1150 Eastlake Ave E

SDCI Project # 3026536

Design Review Board Recommendation

West Design Review Board
March 13, 2019

A. Building Conceptual Forms: The Forest

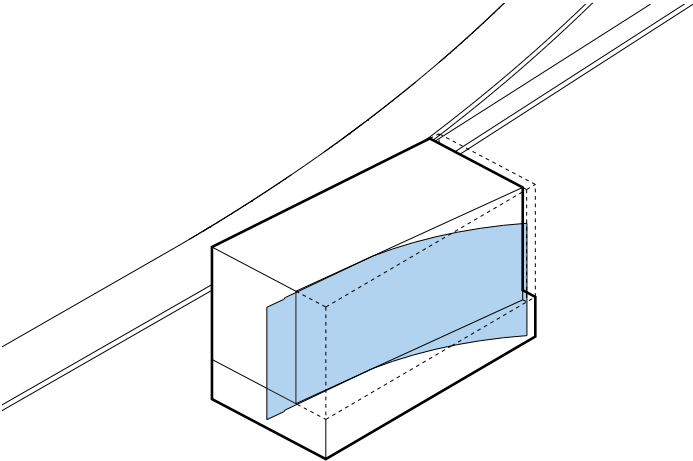
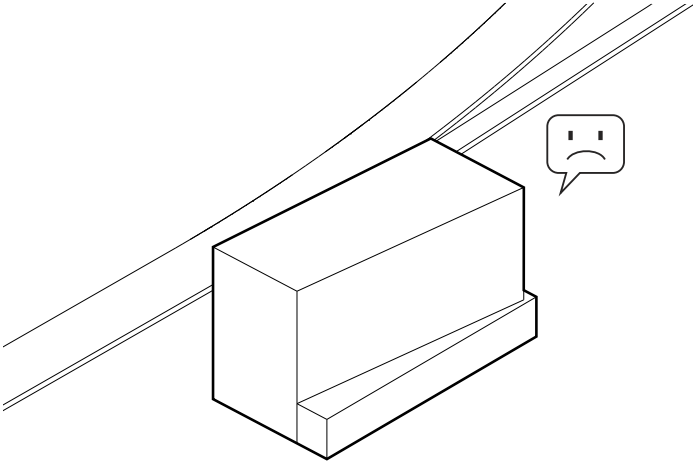
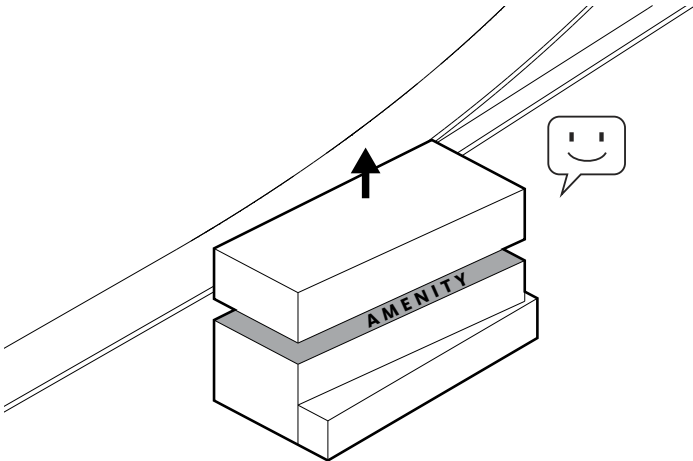
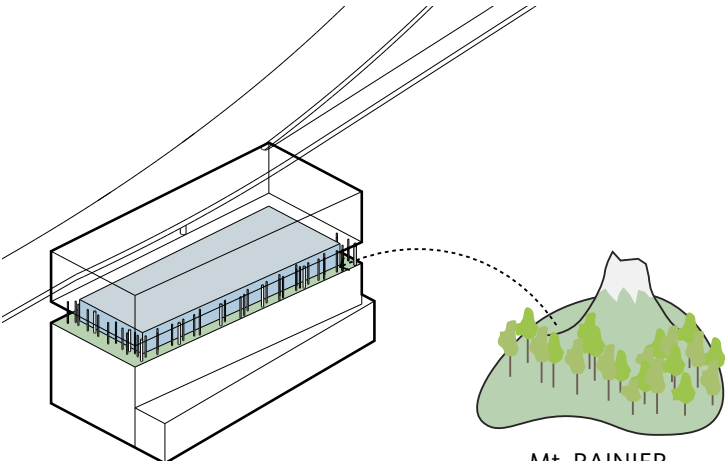
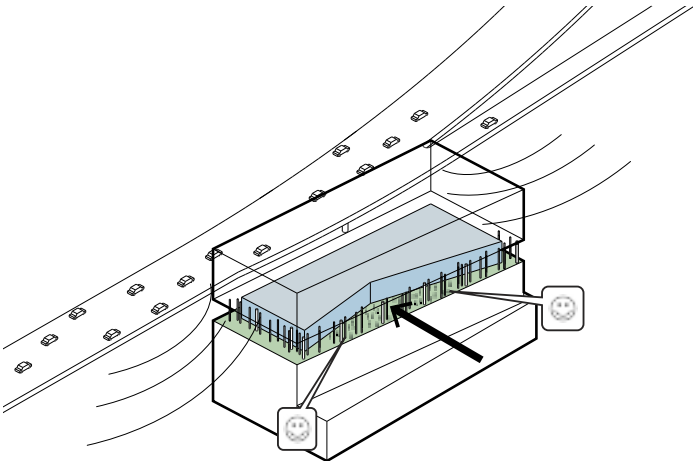
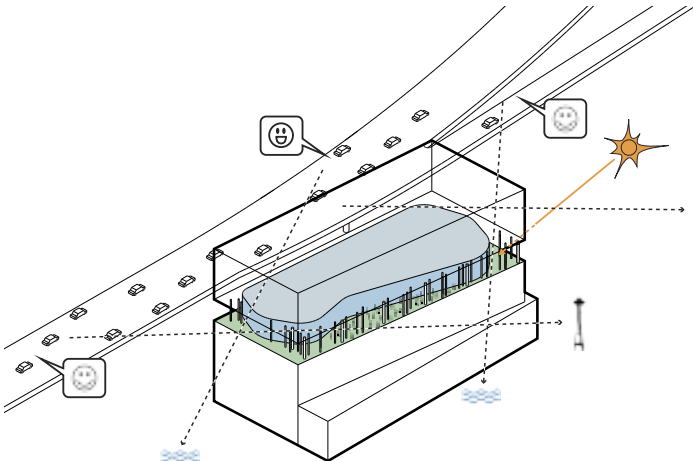
“The Board supported option # 3 and the evolving concepts that engender the conceptual architectural sliding forms.”

The current proposal is based on Option #3: The Forest.

- The response to the shoreline setback sets up a wedged shaped podium fronting a wedge shaped tower.
- The tower block is split at the I-5 level to expose the Forest
- The massing within the Forest is contoured to create a refuge from noise and increase view corridors

B. Overall Massing

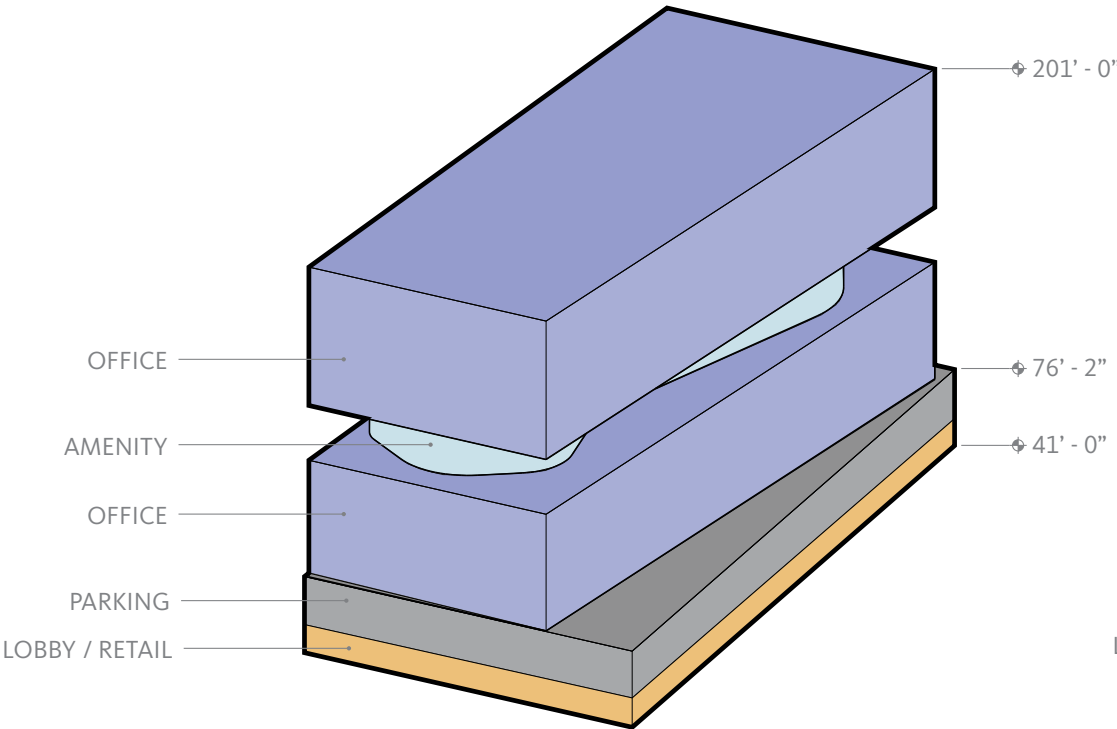
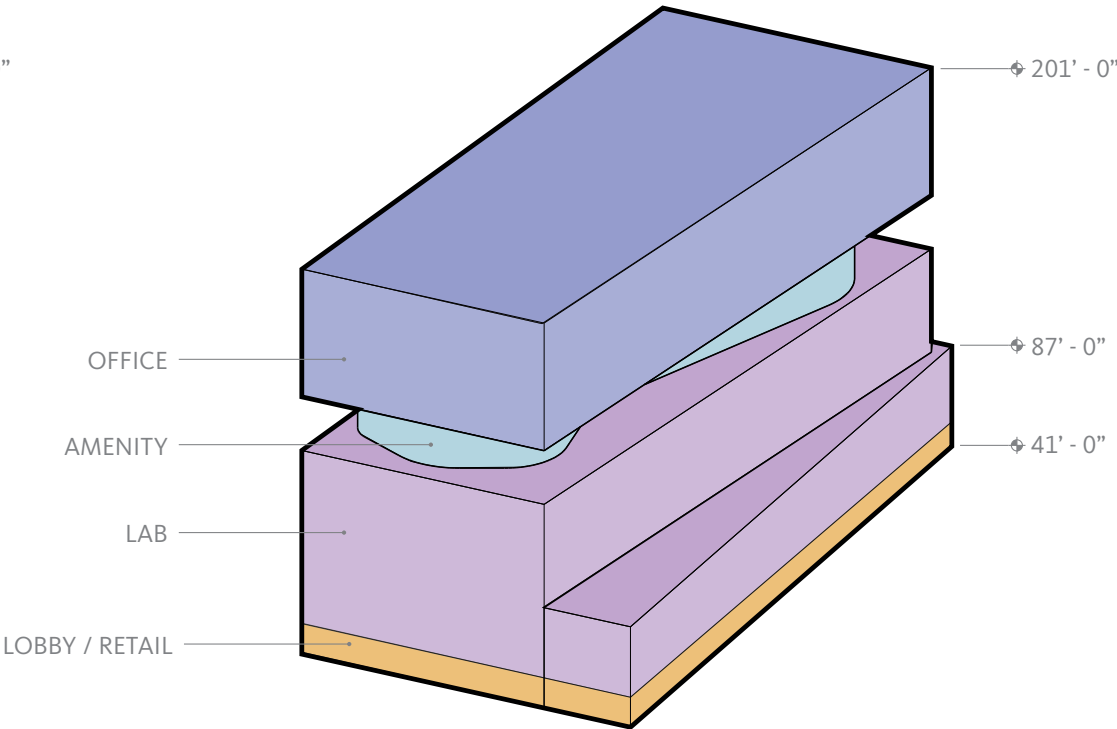
“The Board appreciated efforts for future flexibility that would be “built in” to the program.”

Massing of the updated proposal remains consistent with the EDG option #3.

- The planned future flexibility for program area on Level 2 is exercised by the Owner due to market demand.
- The podium height is increased to accommodate office and lab use in lieu of parking.
- People, not cars, are now the main feature at the podium level

ROOF PLAN

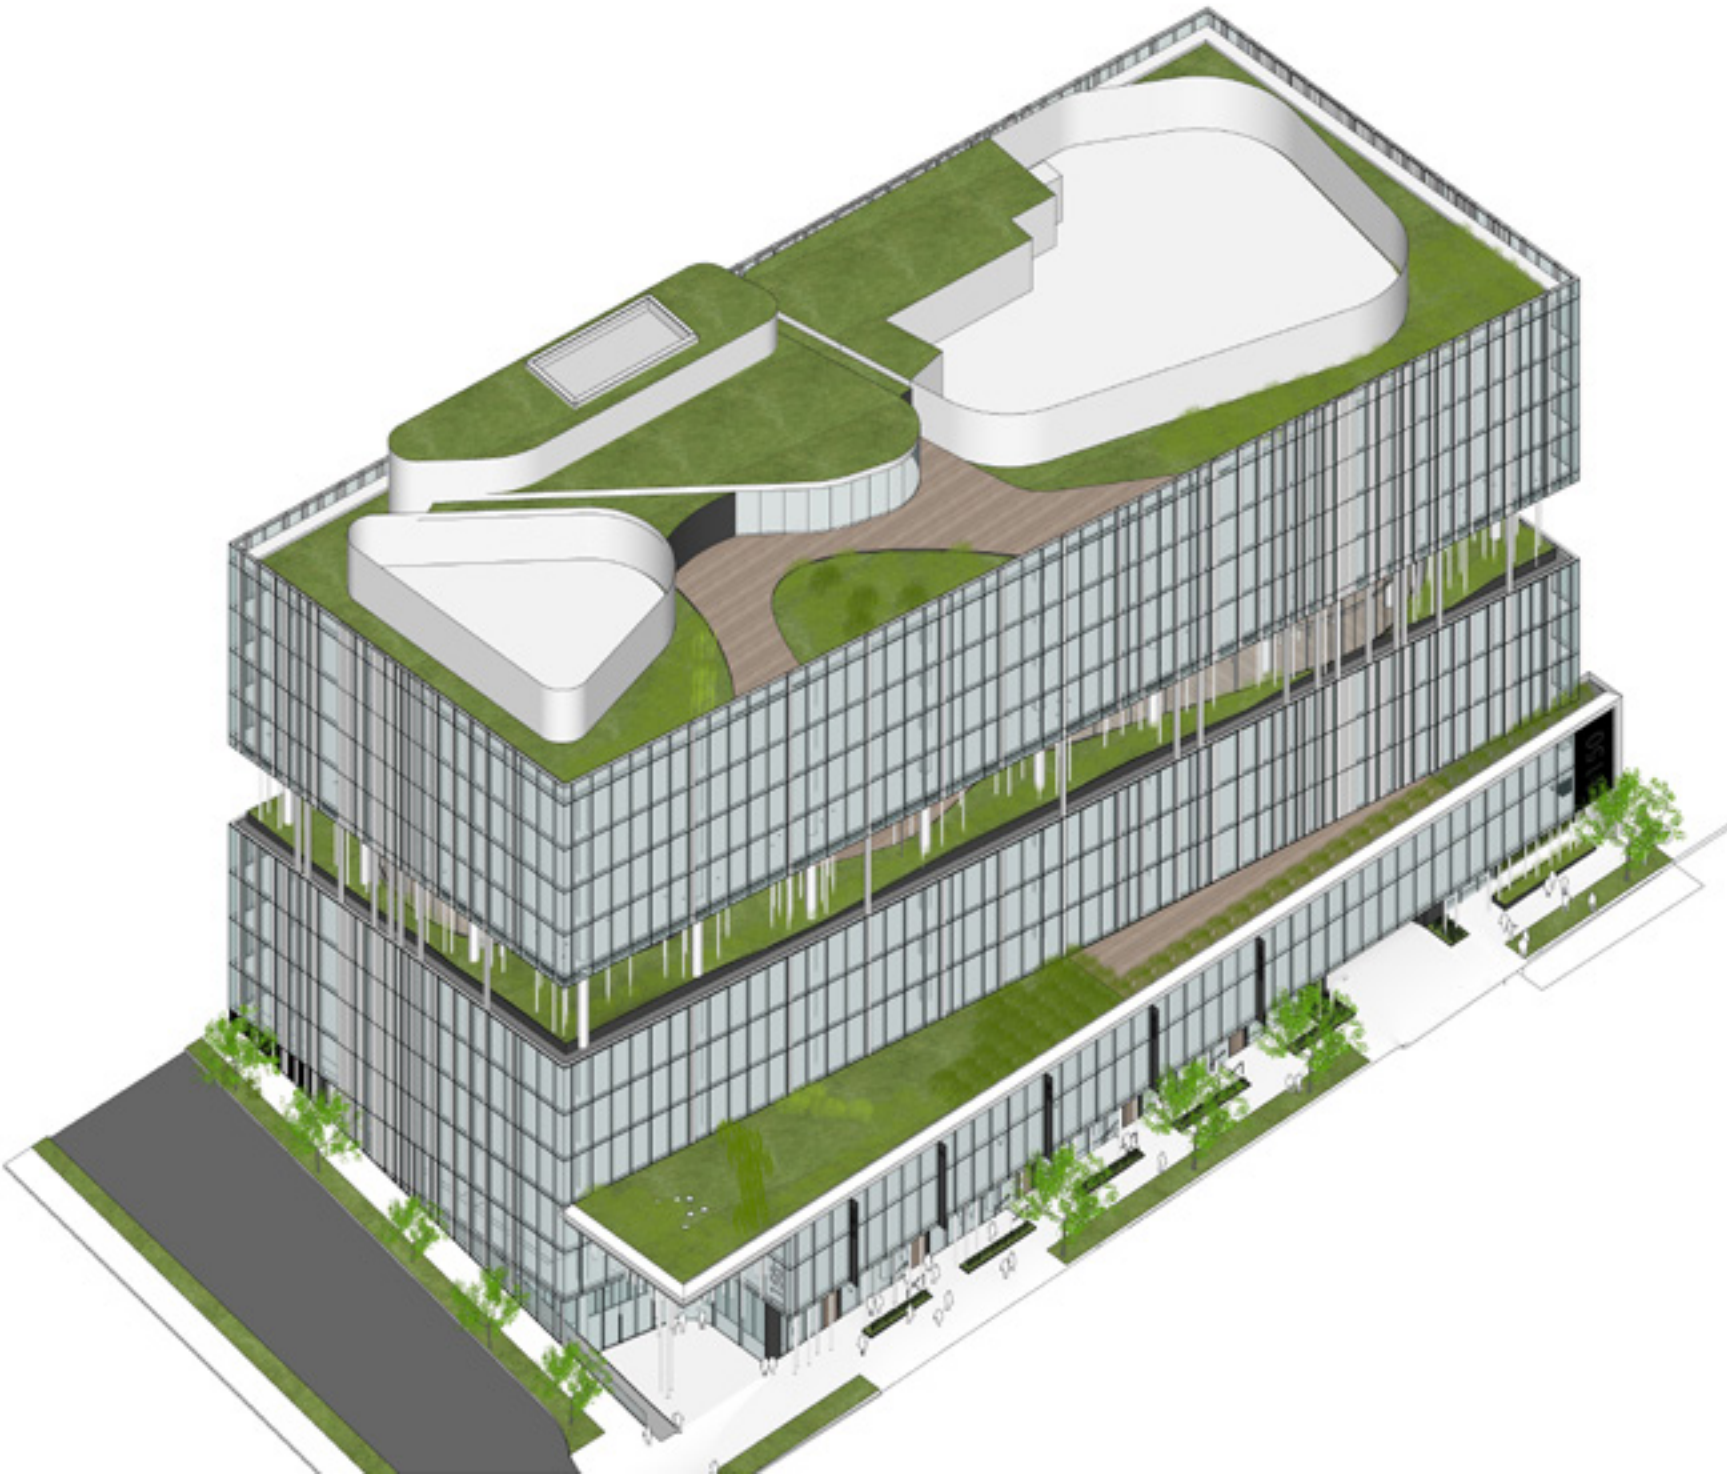
“The Board supported the importance of designing all four facades and to include the roof as a fifth façade worthy of design attention since it will be visible from some points above I-5.”

All four facades are developed to enhance the Wake theme.

- Additional vertical elements added to the façade so that the Wake effect is amplified as the pattern expands and contracts on each façade.
- Denser portions of the Wake pattern carry across the break vertically to provide continuity

The ‘fifth façade’ on the roof is conceived as the culmination of the Forest and Lake themes.

- Mechanical screens and penthouses on the roof are organically shaped to echo the architectural forms of the “break” (Level 7) and reduce impacts to views from Capitol Hill
- Majority of the roof developed into fully-designed landscaped setting with reference to Gasworks Park and green roof

D. The Break

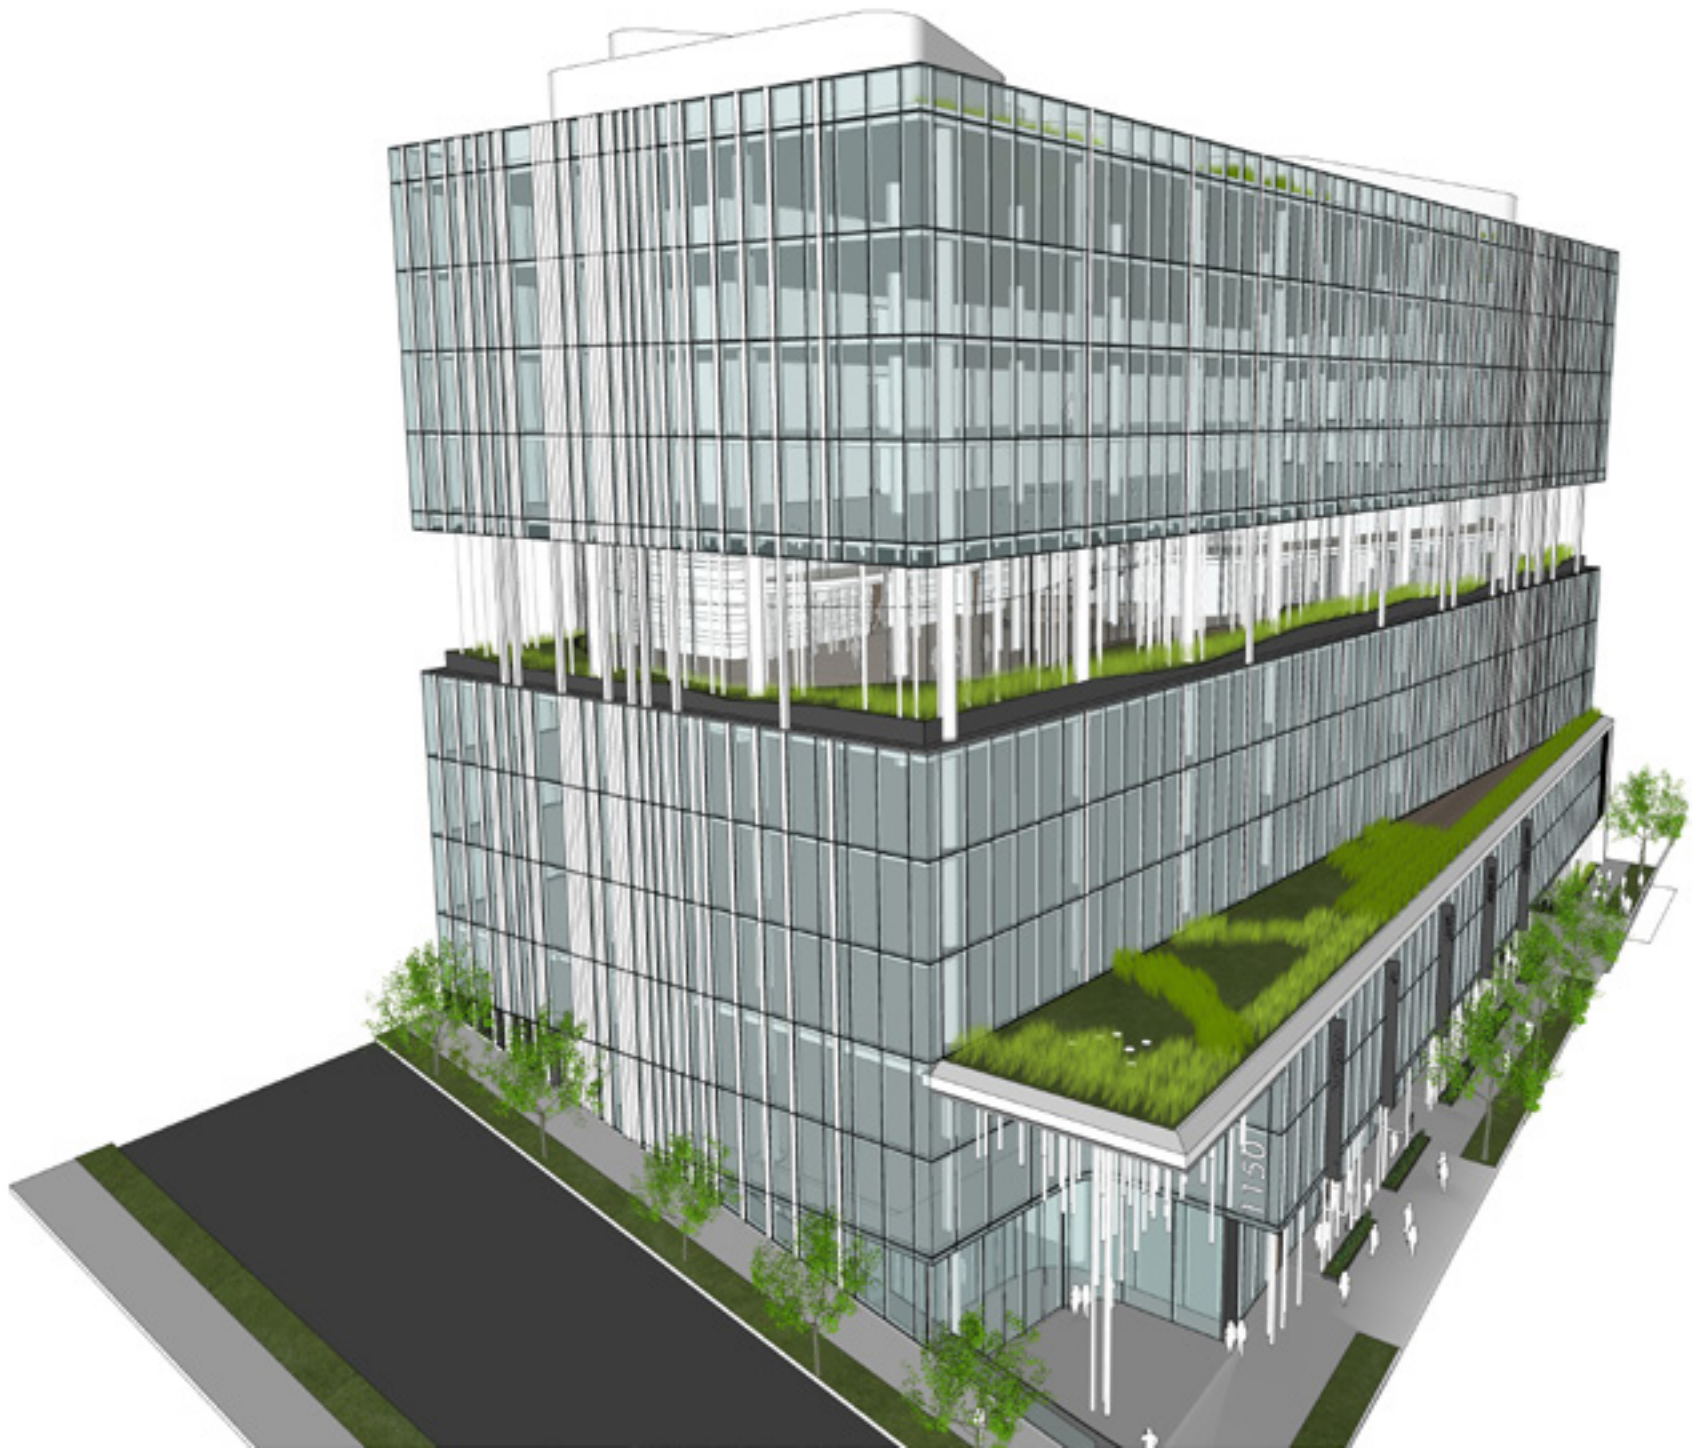
“The Board was supportive of the building “break” at the I-5 level and directed the applicant to explore the concept more fully including the hanging gardens landscape context. The members expressed opinions that the building break was appropriate to opening views and added a sense of lightness to the building.”

The ‘break’ at levels 7 and 8 remains a key element of the building massing and continues around the entire building.

- The Forest is developed in an abstract way, removing the literal (and unsustainable) green vertical elements.
- Landscape design incorporates lush terrain that sets the field for vertical elements evocative of the forest with a high level of visibility from all sides.
- Primary structural columns are supplemented with slender columns to invoke the varying textures of the forest and pay formal homage to the Steam Plant

A. Southwest Corner

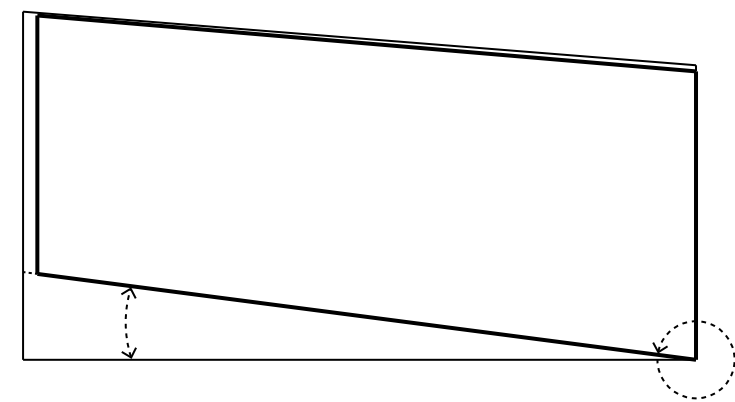
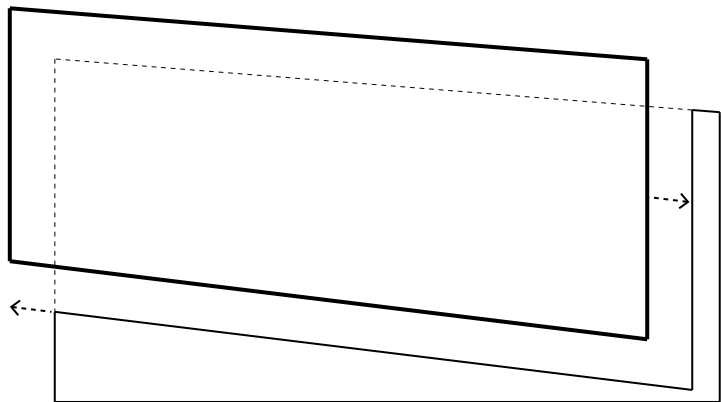
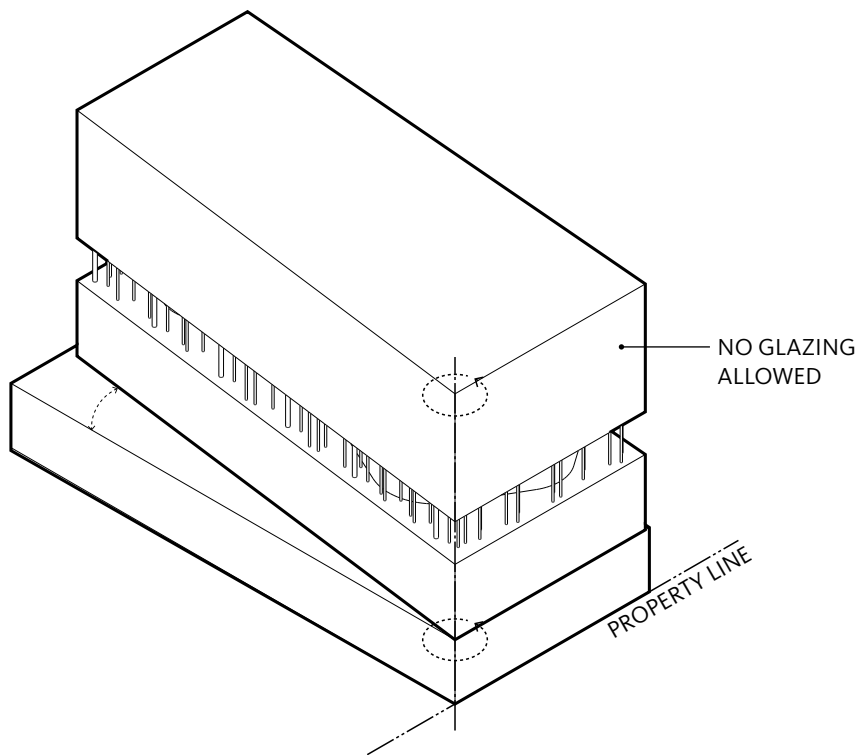
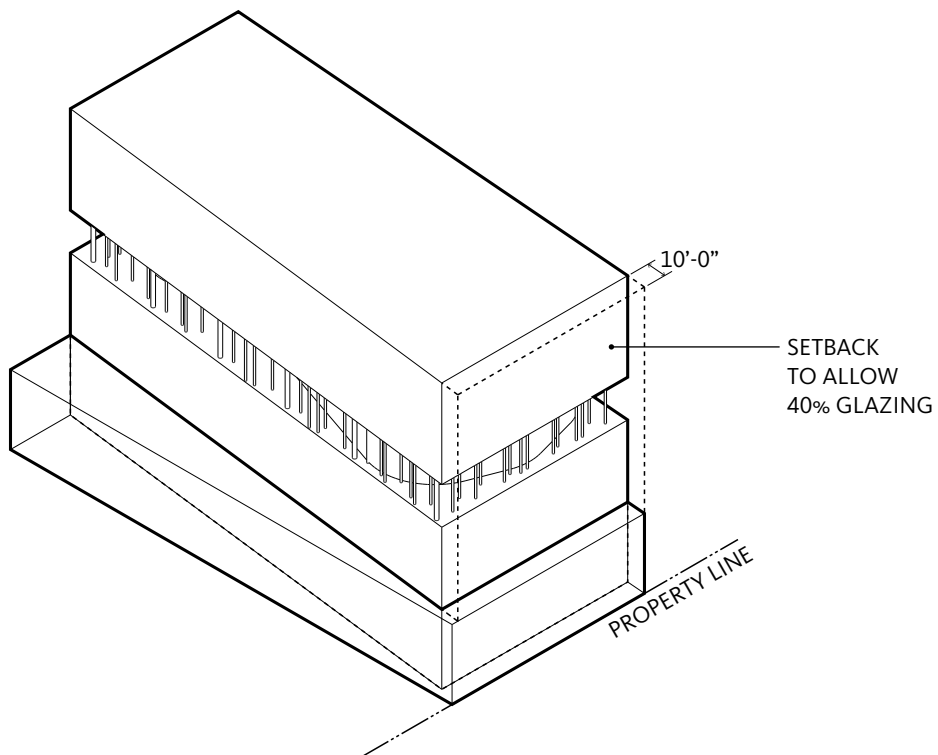
“The Board thought that the southwest corner of the building was evolving as a central pivot point for sliding building forms. To explore that idea, develop a vertical element at the southwest corner from top to bottom to express an organizing fulcrum or moment which energizes and collects the architectural moves of the building.”

The southwest corner is developed as the corner of a ‘slice’ rather than a pivot.

- Podium scaled to the street
- Podium as a foil to the mass and distinct materialities of the tower.
- Podium developed as a pedestrian oriented façade that respects the proportions of the adjacent buildings
- Podium introduces primary architectural features, beginning at the anchor point to the south and culminating at the main entry to the north
